Site Accessibility Evaluation

**Pikes Peak Community
College Transfer Station
PU18-0083**

**5675 S Academy Blvd
Colorado Springs, CO
80906**

SUBJECT: Pikes Peak Community College Transfer Station Self-Evaluation

Image of gap in sidewalk

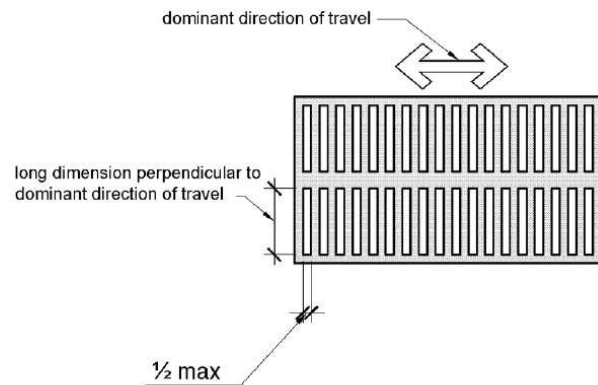
Finding: 2

The concrete expansion joint is spaced greater than 1/2 inch.

There is a 1" wide gap for the length of 7 panels.

Clean out and fill the gap.

Image of sidewalk with excessive running and cross slopes

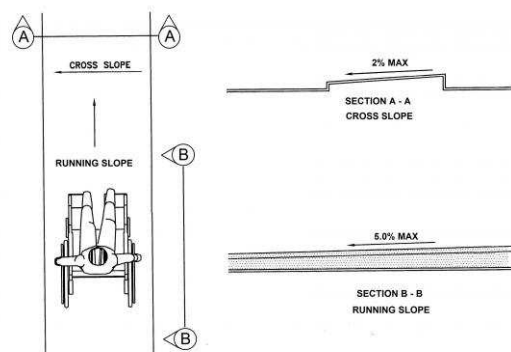
Finding: 4

The accessible route contains running slopes greater than 5 percent and cross slopes greater than 2 percent across the width of the walk and has not been constructed as a ramp (i.e. handrails, wheel guides, etc.).

The running and cross slopes of 2 panels are up to 4%.

Remove and replace the panels to provide maximum 2% slopes.

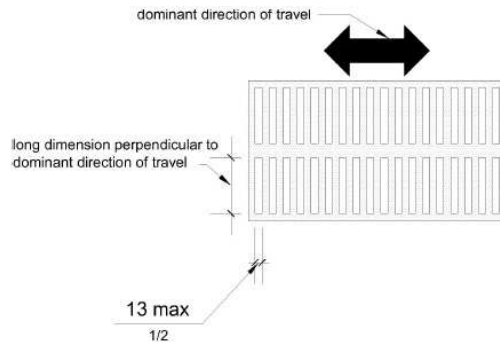
Finding: 5

The surface of the pedestrian access route has openings greater than 1/2 inch.

Near the ticket kiosk, there are up to 1-1/2" wide gaps and up to 1" vertical displacement.

Grind to less than 1/2" bevel. Clean out and fill gap.

Image of bus shelter trash can

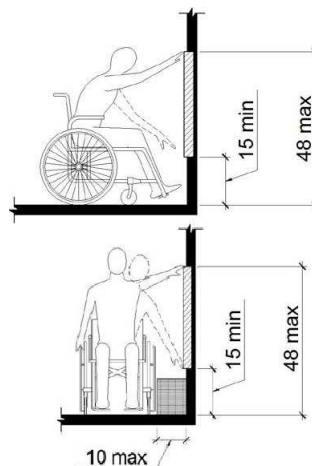
Finding: 6

The trash can is positioned too high for either a side or front approach.

The trash can on the right of the last shelter is 50-1/2" to the operable portion.

The trash can is not required to meet reach ranges. However, when this trash can is replaced, replace with one that is maximum 48" to the operable part.

Image of sidewalk with excessive slopes

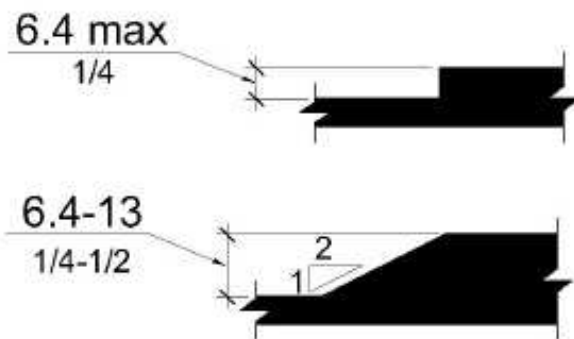
Finding: 7

There are 6 panels with slopes between 2% and 3%.

There is a gap up to 1-3/4" wide, up to 1-1/2" deep, with up to 3/4" vertical displacement.

There are several issues with the sidewalk near the last shelter.

Remove and replace the panels.

Image of gaps and vertical displacement in sidewalk

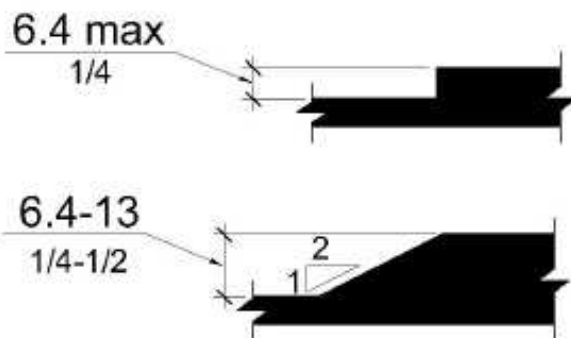
Finding: 8

There are gaps up to 1-1/2" wide, and up to 1/2" vertical displacement.

Near bay #35, there are multiple issues with the sidewalk.

Grind to less than 1/2" vertical displacement. Clean out and fill gap.

Image of gaps and vertical displacement in sidewalk.

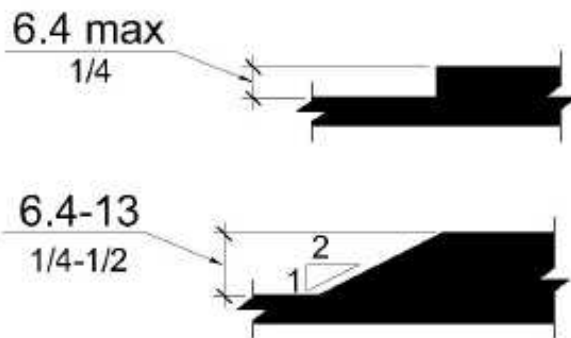
Finding: 9

There is a 1" gap and up to 3/4" vertical displacement.

There are multiple issues with the sidewalk near bay #27.

Grind to less than 1/2". Clean out and fill gaps.

Image of bus stop schedules mounted too high

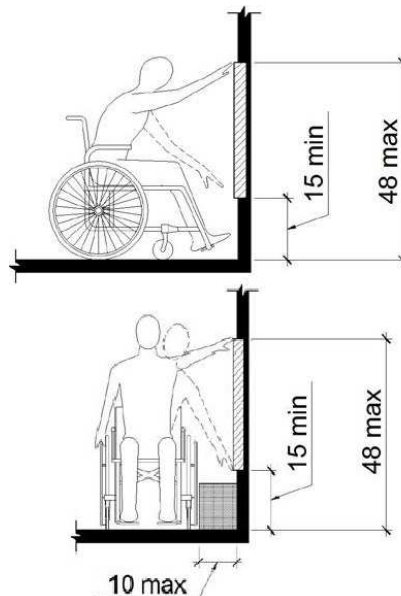
Finding: 10

The bus schedules are positioned too high for either a side or front approach.

The reach range to the bus schedules is 52".

Lower the bus schedule box to 48" maximum.
